SERVICE BULLETIN

TS-520/S, TS-820/S #842

SUBJECT: DS-2 Replaces DS-1A DC-DC Converter

DATE 01/26/81

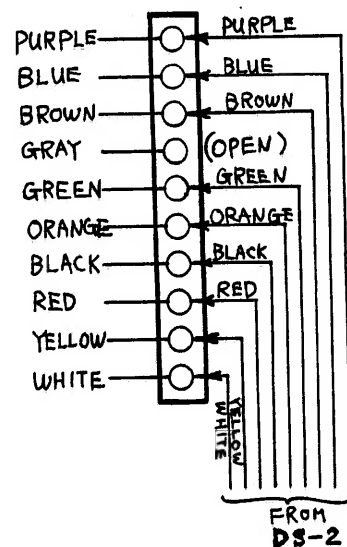
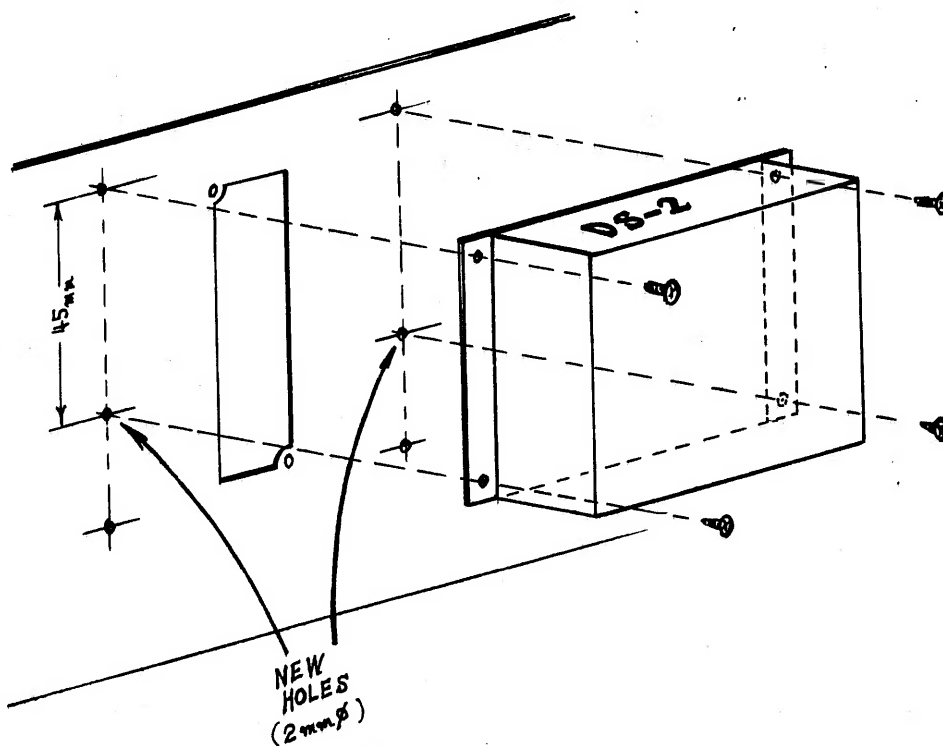
The DS-1A DC-DC converter for the TS-820 series and TS-520/S has been replaced by a new model, the DS-2. Wiring color code is the same. Physical size is smaller. Two additional mounting holes must be drilled in the transceiver rear panel.
